97 Physical Coding Sublayer (PCS), Physical Medium Attachment (PMA) sublayer, Physical Medium Dependent (PMD) sublayer, and baseband medium, type 1000BASE-T1

97.7 Operations, Administration, and Maintenance (OAM)

97.7.3 OAM Register Requirements

Figure 97 – P - Transmit State Diagram

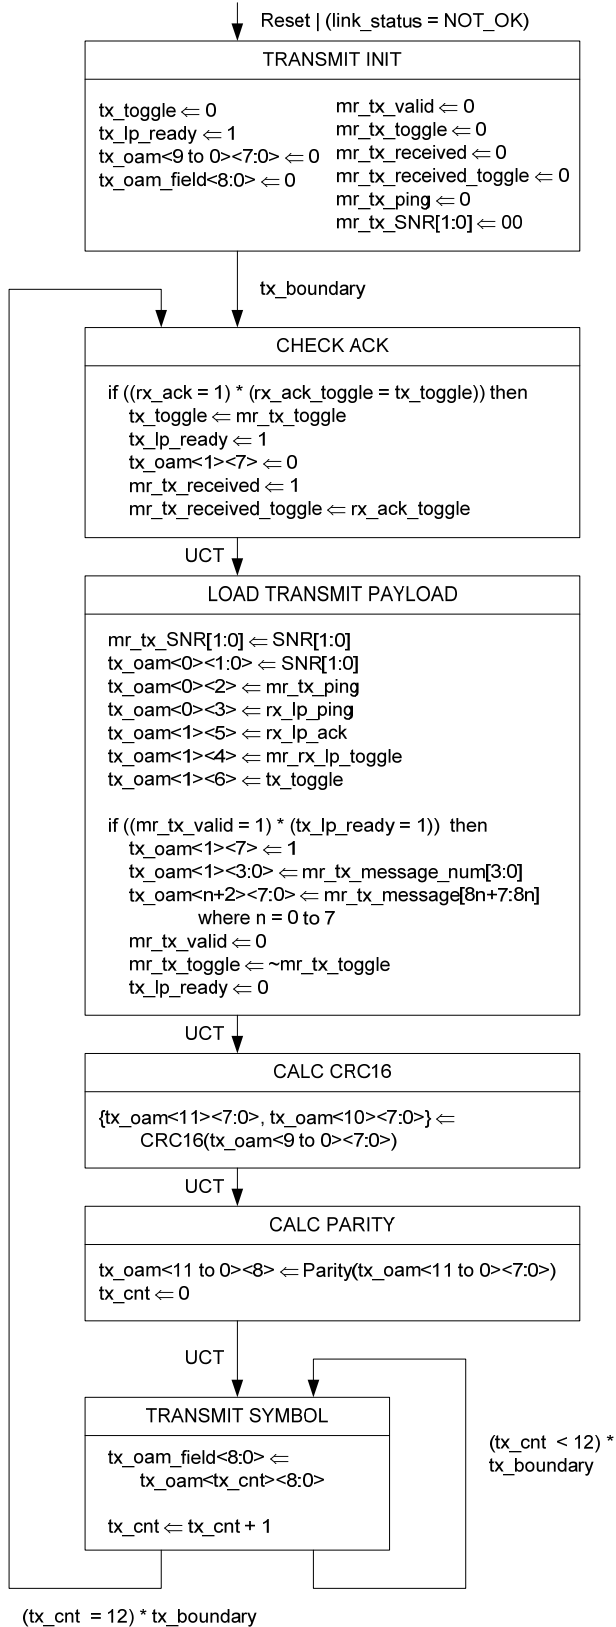
97.7.4.4 State Diagrams
 (remove editor's note)
